APPLICATION NO.	F	FILING DATE	FIRST NAMED INVENTOR	ATTORNEY DOCKET NO.	CONFIRMATION NO.
10/823,854	04/14/2004		Paul Tashjian	PTJ-101US	5501
23122	7590	08/15/2006		EXAMINER	
RATNERP	RESTIA		CHAMBERS, TROY		
P O BOX 98 VALLEY FO		'A 19482-0980	ART UNIT	PAPER NUMBER	
	- /		3641		
			DATE MAILED: 08/15/2006

Applicati n N .	Applicant(s)	Applicant(s)				
	Office Action Summary	10/823,854	TASHJIAN, PAUI	L				
	Office Action Summary	Examiner	Art Unit					
		Troy Chambers	3641					
Peri d fo	The MAILING DATE of this communication ap or Reply	pears on the cover sheet	with the correspondence a	ddress				
WHIC - Exter after - If NO - Failu Any r	CHEVER IS LONGER, FROM THE MAILING Ensions of time may be available under the provisions of 37 CFR 1. SIX (6) MONTHS from the mailing date of this communication. period for reply is specified above, the maximum statutory period re to reply within the set or extended period for reply will, by statutely received by the Office later than three months after the mailing patent term adjustment. See 37 CFR 1.704(b).	DATE OF THIS COMMUN 136(a). In no event, however, may will apply and will expire SIX (6) Mile, cause the application to become	NICATION. a reply

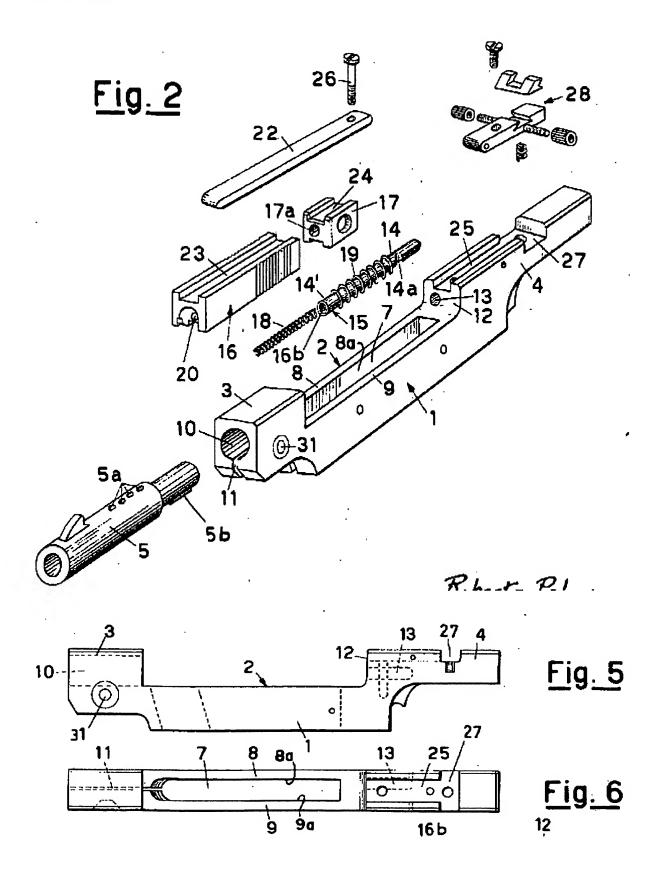
8. Claims 1, 2 and 5 are rejected under 35 U.S.C. 102(b) as being anticipated by US 3711980 issued to Palama. Palama discloses a receiver for a firearm as shown below.

As shown in Figs. 5 and 8 of Palama, the greatest outer diameter of the barrel 5 is larger than the opening at 10.

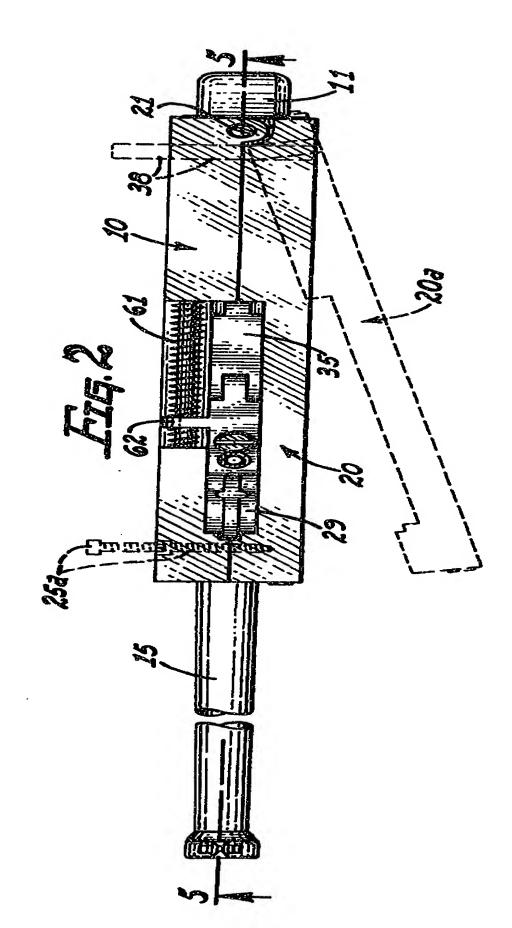
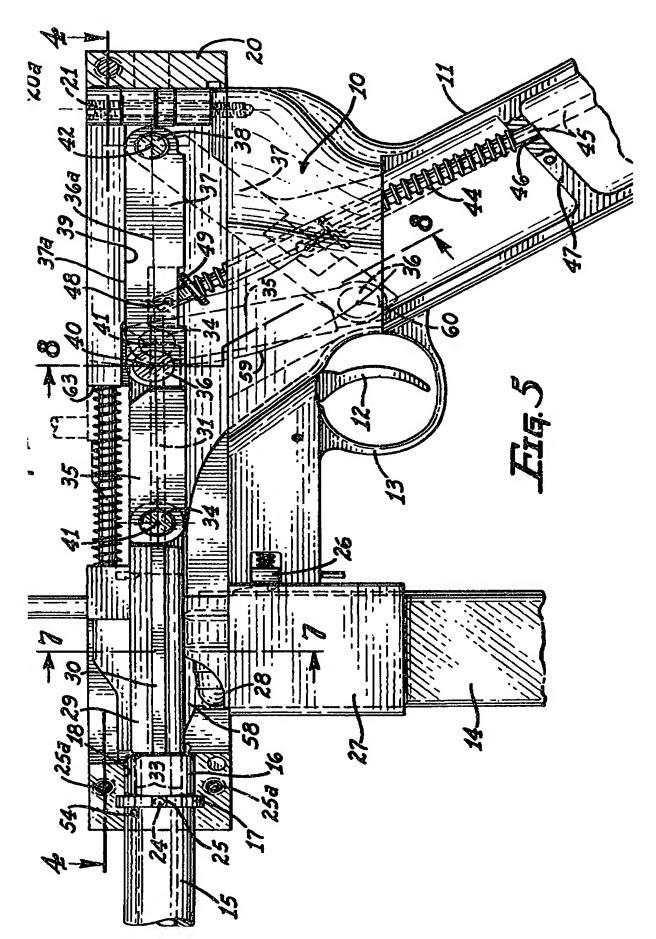
9. Claims 1, 2 and 5 are rejected under 35 U.S.C. 102(b) as being anticipated by Canadian Patent 925334 issued to Perrine. Perrine discloses a firearm as shown below.

13. Perrine continues to anticipate as well. Perrine discloses a barrel 15 having a flange 17 (larger diameter) received within a bore 18 (Perrine, pg. 4, line 29 to pg. 5, line 3; and, Fig. 5).
